COMMODITY: CONSTRUCTION OF NEW 400' RADIO TOWER & TRANSMITTER BLDG. DATE: 1/2/25

FORMAL BID NO. _____ PUBLIC BID NO. 101448

**BID 101448 – CONSTRUCTION OF NEW 400’ RADIO TOWER & TRANSMITTER BLDG.
QUESTIONS AND ANSWERS**

TOWER ELEVATION & OMNI ANTENNA PLANS
 PROPOSED GUYED TOWER
 975 PLAINS ROAD
 TOWN OF SOUTH KINGSTON
 WASHINGTON COUNTY, RI 02892
 DATE: 12/15/20
 SHEET NO: C200
 OF: 3

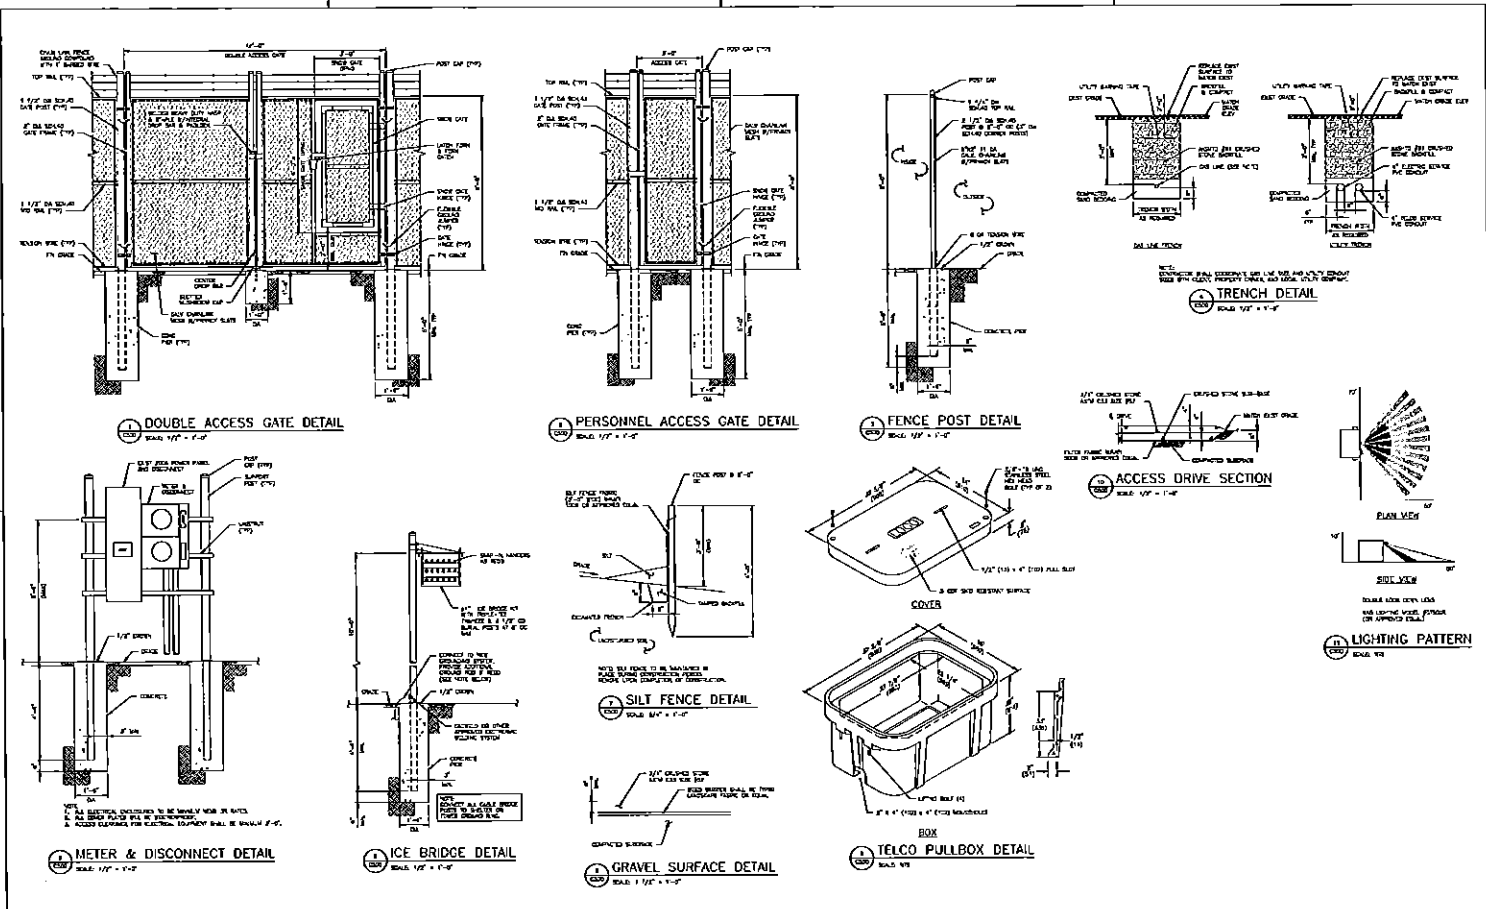
6. Detail of Antenna Quantity / Model and Mount detail as well.

Answer 6: See chart on C200 for details. Antenna: Shively 6813-4.
